Case No. 2025-00177
Barrelhead Solar, LLC
Response to Siting Board's Second Request for Information

Siting Board 2-1:

Siting Board 2-67:

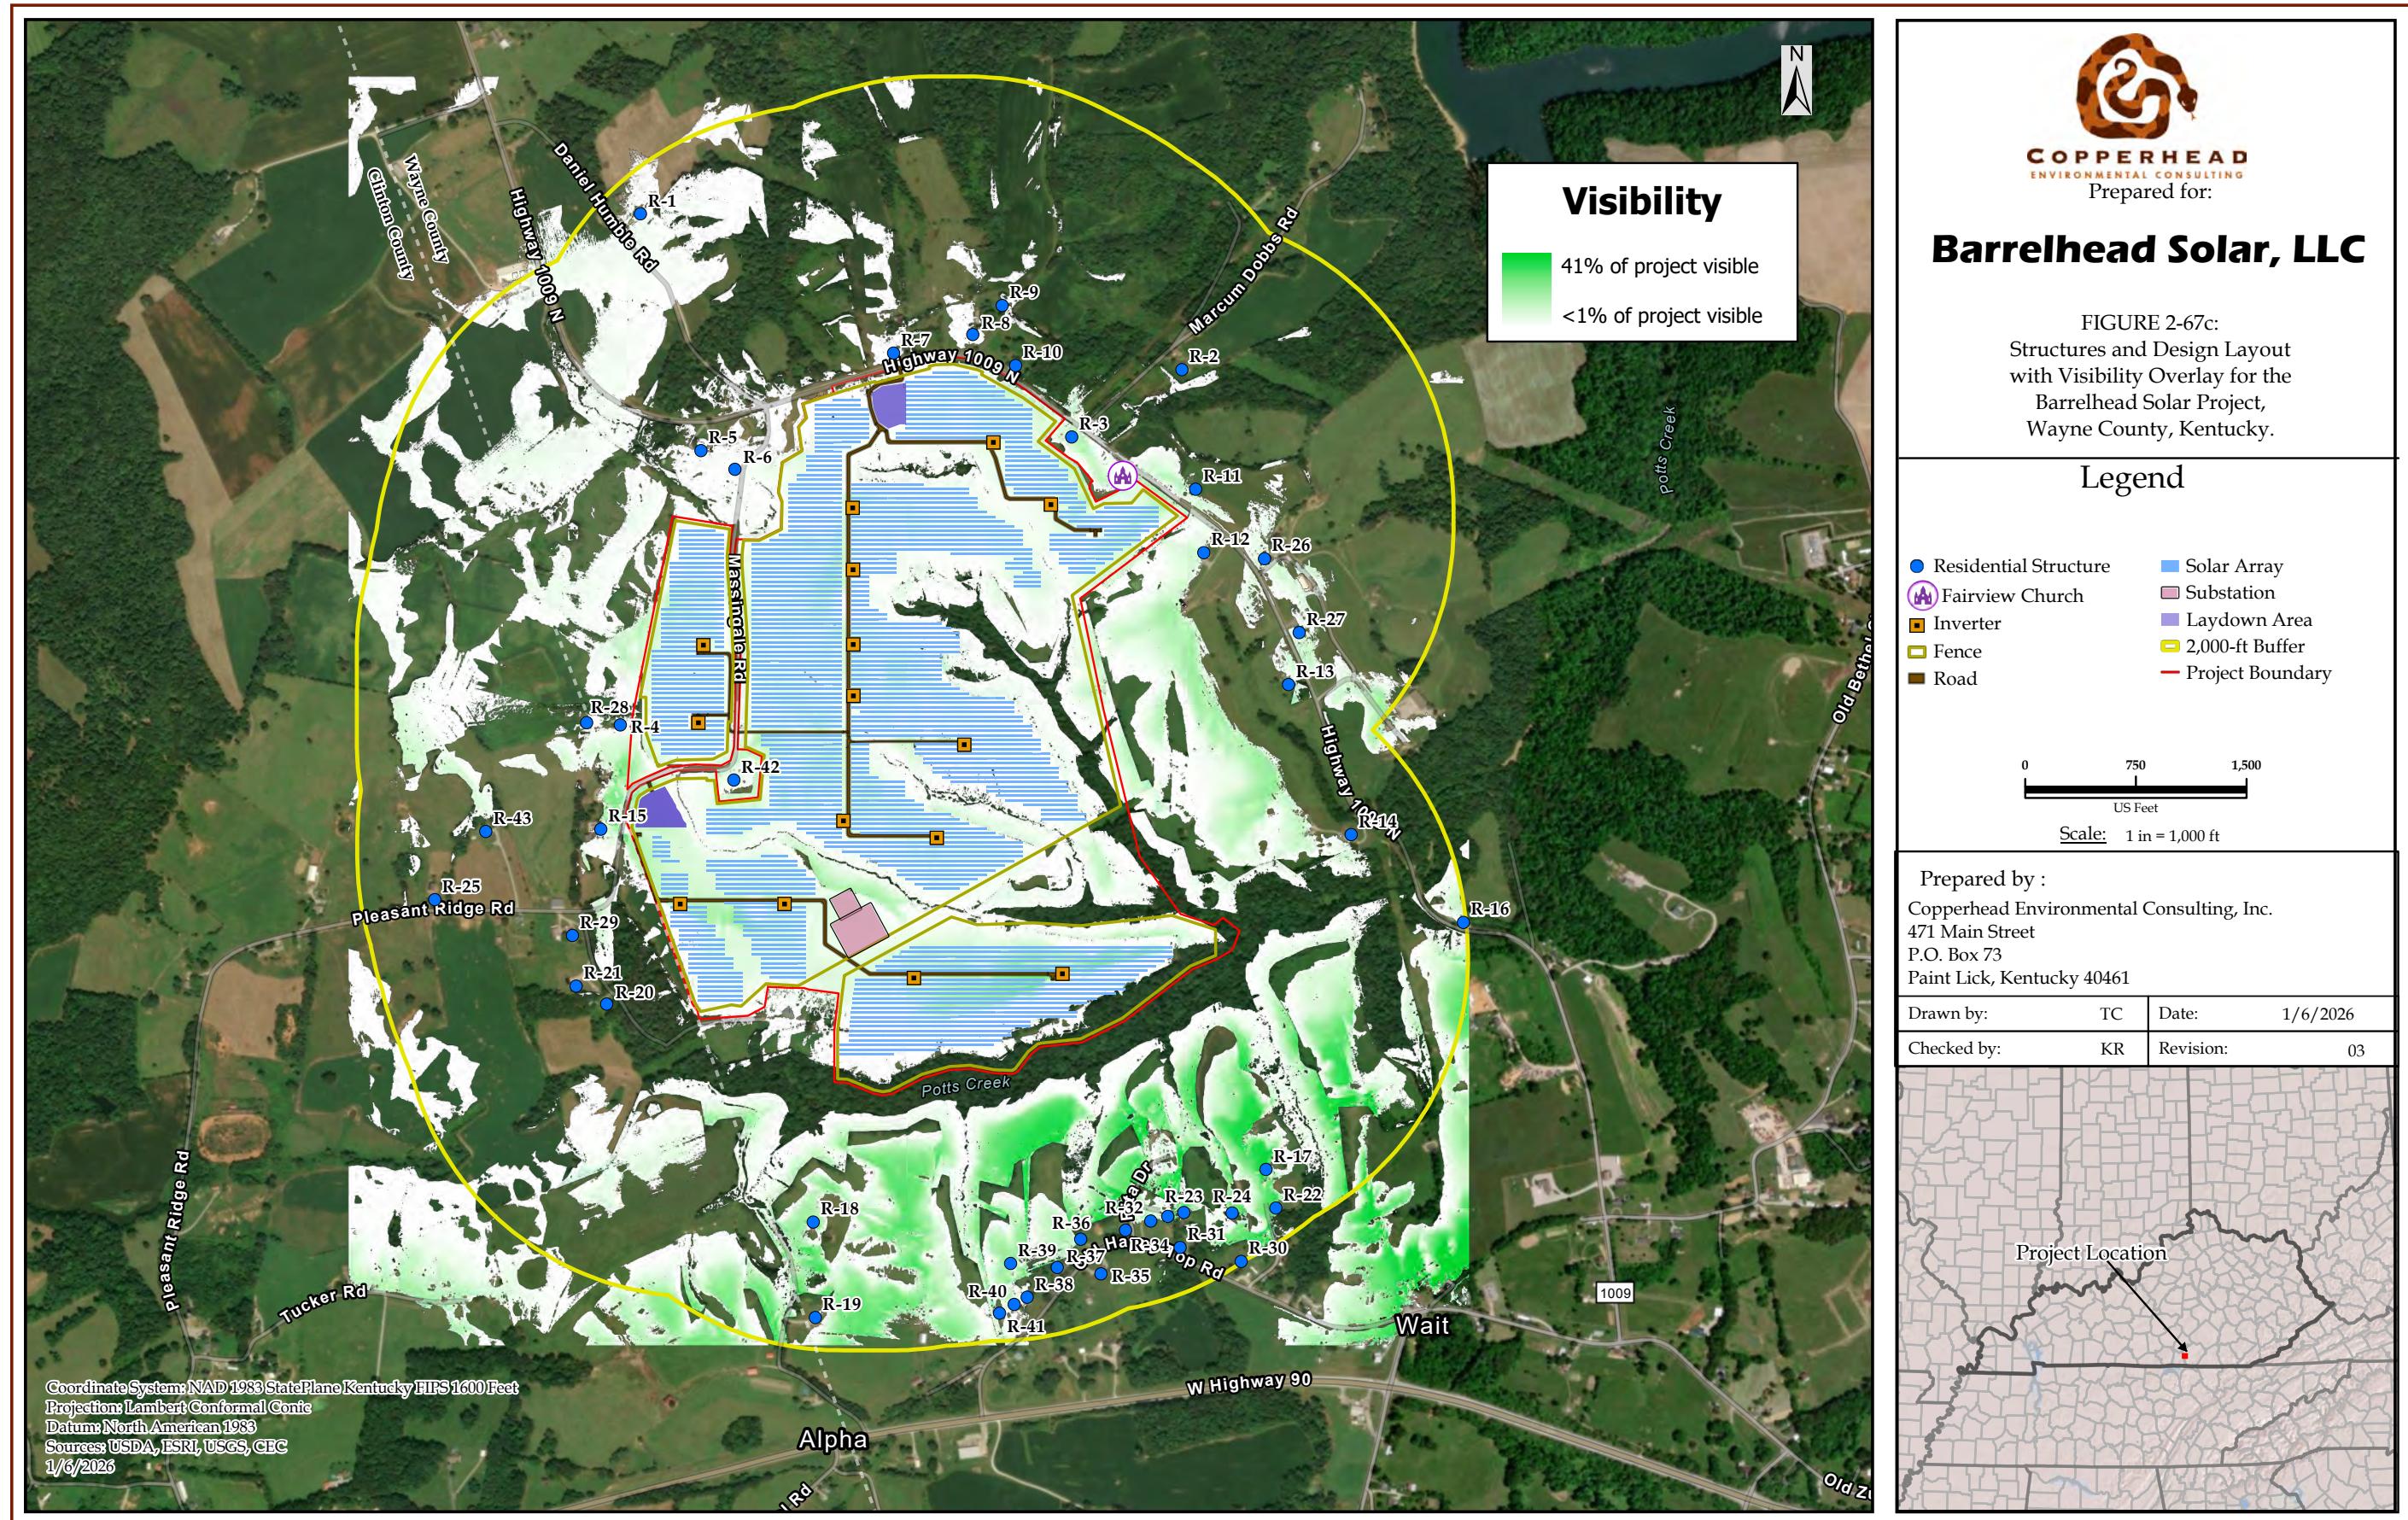
Refer to Barrelhead Solar's response to Staff's First Request, Item 59. Figures 1 and 2 include a different total number of receptors and different numbering system for the receptors than shown in Figure 3. Explain these differences and provide revised Figures with consistent receptor numbering.

Response: Figures 1, 2, and 3 from the visibility analysis have been revised and provided as Attachment 2-67. The numbering system in the revised maps uses the updated/simplified labeling developed for this RFI. The difference in numbering between the previous maps was clerical error.
